**EL PASO COUNTY PLANNING AND
 COMMUNITY DEVELOPMENT
 DEPARTMENT**

CONSTRUCTION DRAWINGS CHECKLIST

OUTLOOK POWERS & GRINNELL

CIVIL CONSTRUCTION PLANS

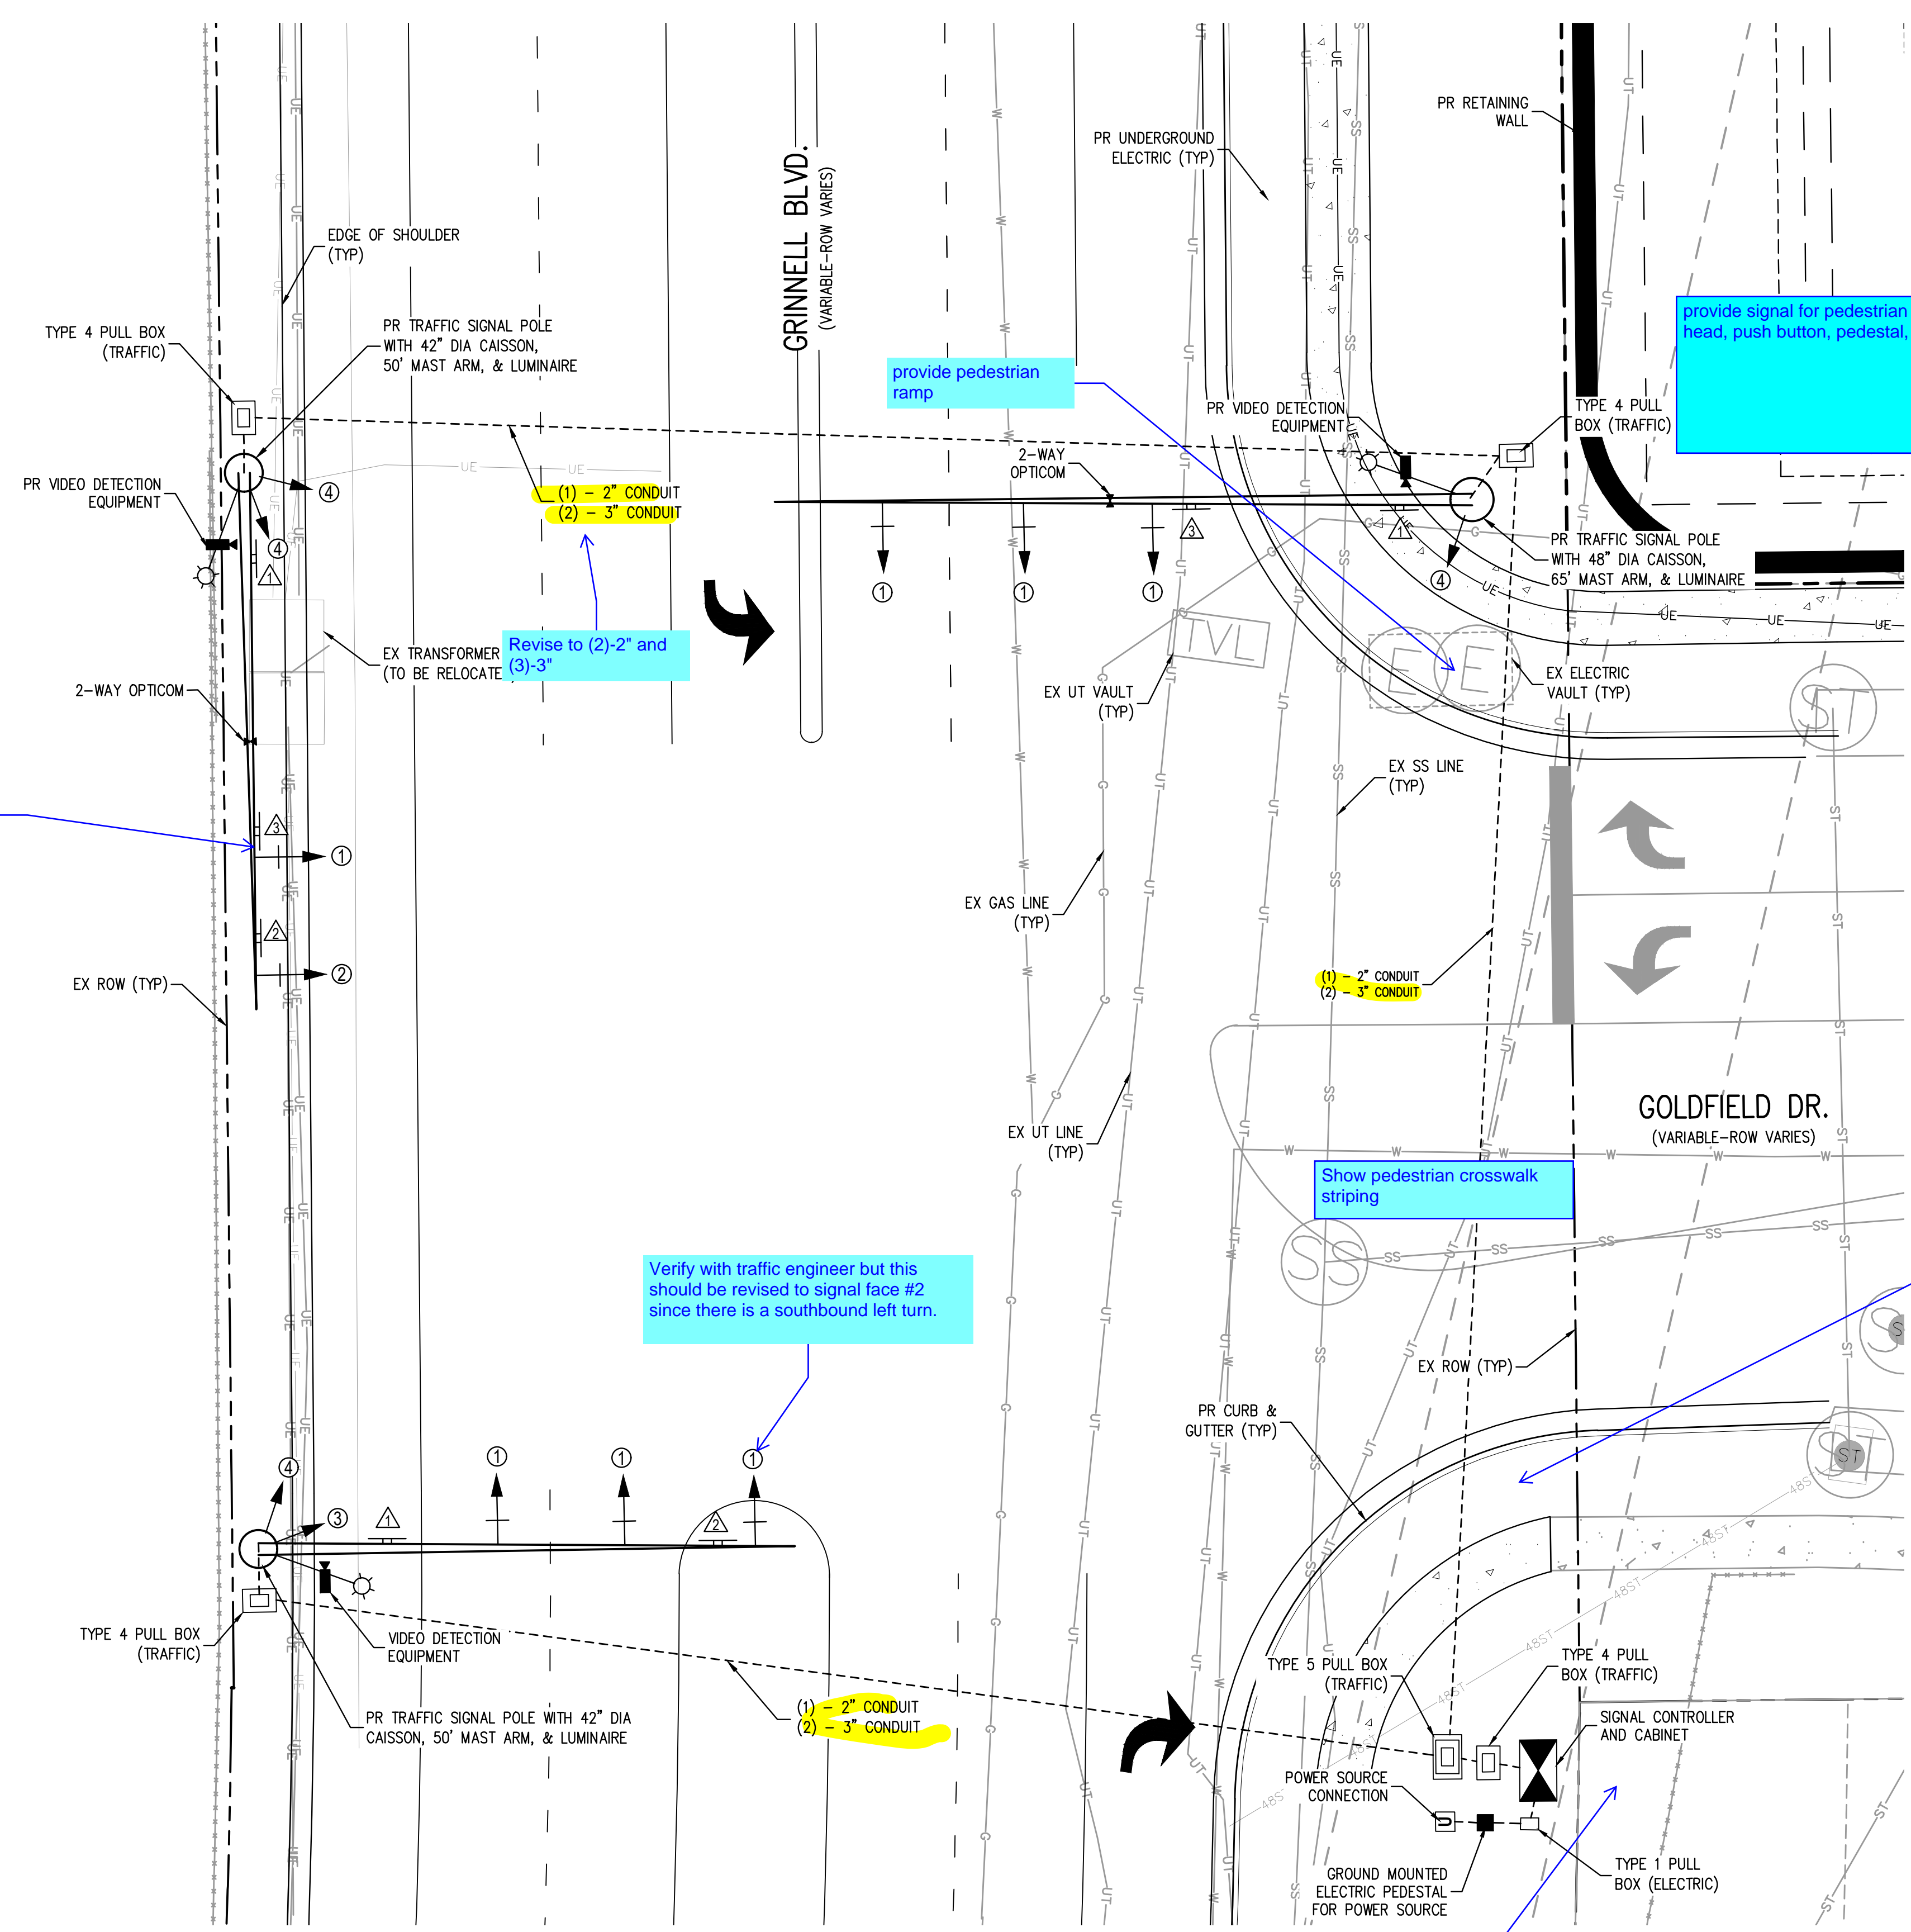
Staff will verify with Highways if this should be a 4-section vertical head to include a flashing yellow arrow.
